ALBERTA ENERGY and UTILITIES BOARD

APPLICATION NO. 1409180

APPLICATION TO SHUT-IN GAS PRODUCTION

**Responses of EnCana Oil and Gas Partnership (EnCana) to
Board Staff Information Requests (September 19, 2006)**

Figure 2g.1: Vertical cross-section through model for cases FL21RE and FL22RE sliced from the areal cross-section centre row grids

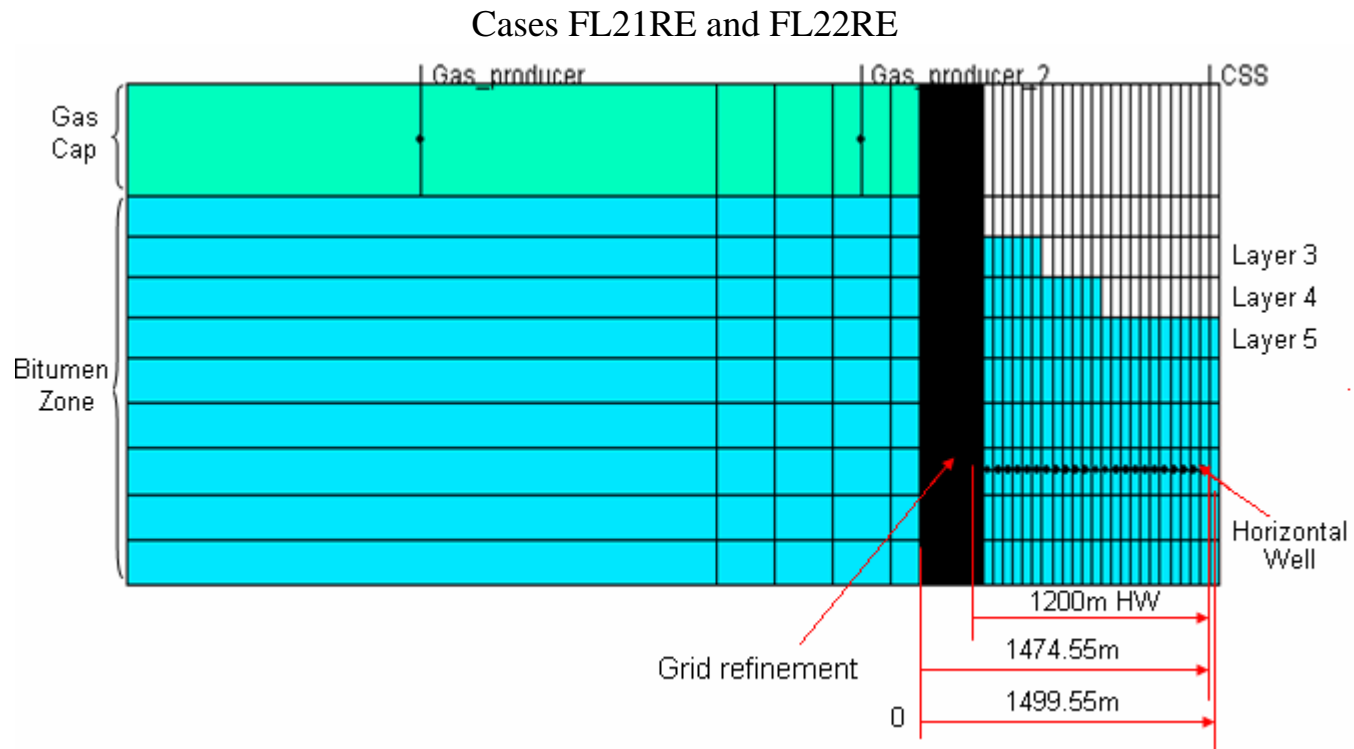
- (g) **On page 5 it is stated that reasons for achieving relatively similar HW CSS bitumen recovery factors in cases involving depletion of the gas cap gas when compared to similar reservoir cases without gas cap production are currently being investigated. However, early analysis results indicate that lower bitumen reservoir pressure below the gas cap, resulting from gas cap gas depletion, allows the steam vapors to rise higher and have better penetration into the upper regions of the reservoir. Why should the Board place any reliance on an explanation that is still being investigated?**

Figure 2g.1 shows the vertical cross-section through the model (FL 21RE/FL 22RE) from the areal cross-section centre row grids. It shows the zero reference point taken from where the grids are well refined close to the edge of the gas cap. Distances are taken from the zero reference towards the edge of the reservoir. It also shows the model layer numbers. The following Figures demonstrate the following:

Figure 2m.1: Showing well block pressure for cases FL2RE and FL22RE using a dilation permeability multiplier factor of 60

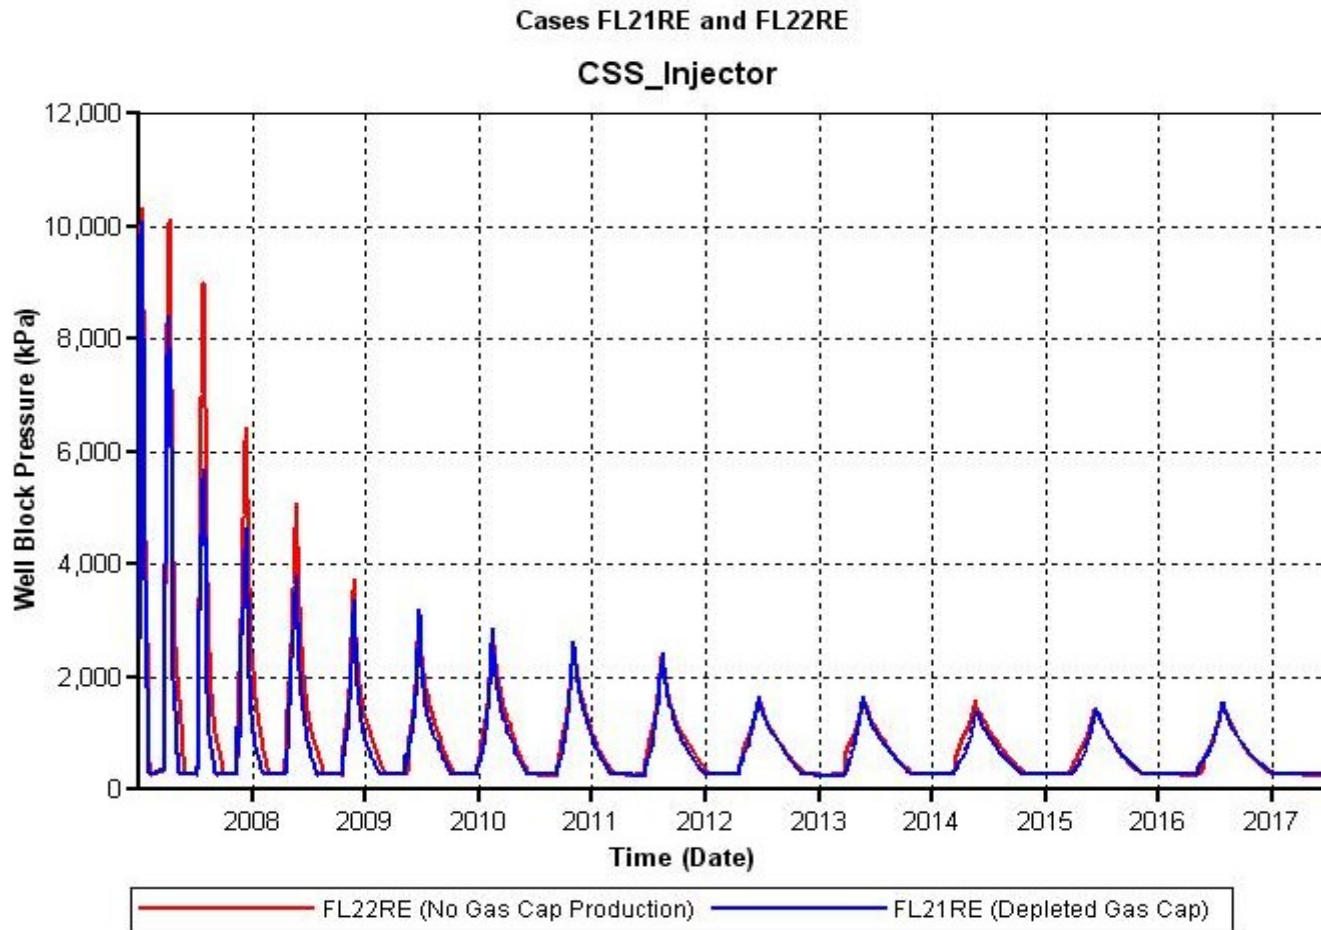
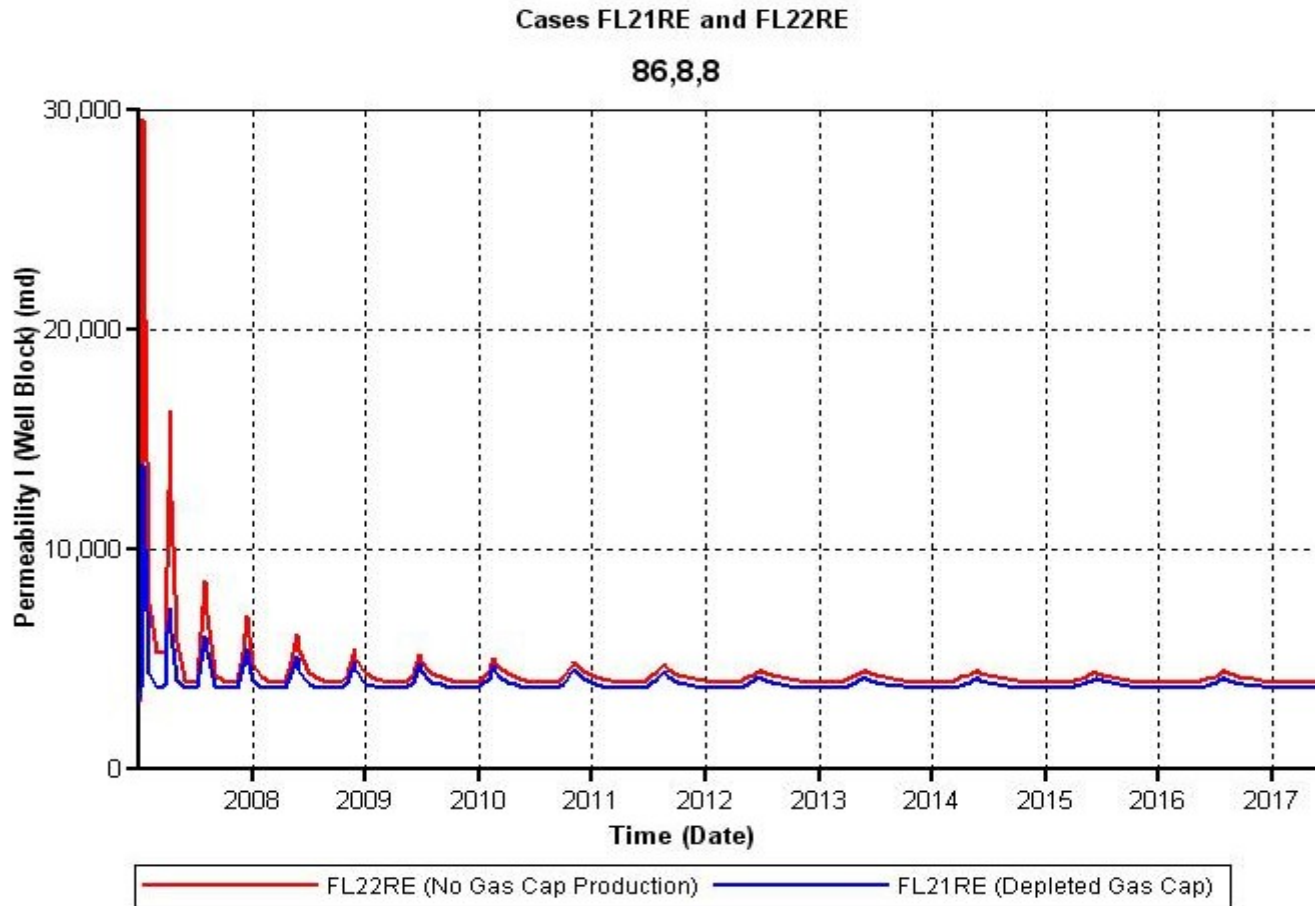
The cases described in the study show permeability multipliers of up to 60 times the initial values used in the study. Considering the high initial permeabilities for the gas and bitumen zones, why is it appropriate to use permeability multipliers of up to 60?

Figure 2m.1 and 2m.2 show the injection pressure and the permeability in assigned fracture well gridblocks as a result of the specified dilation permeability multiplier factor of 60 for FL 21RE and FL 22RE cases.
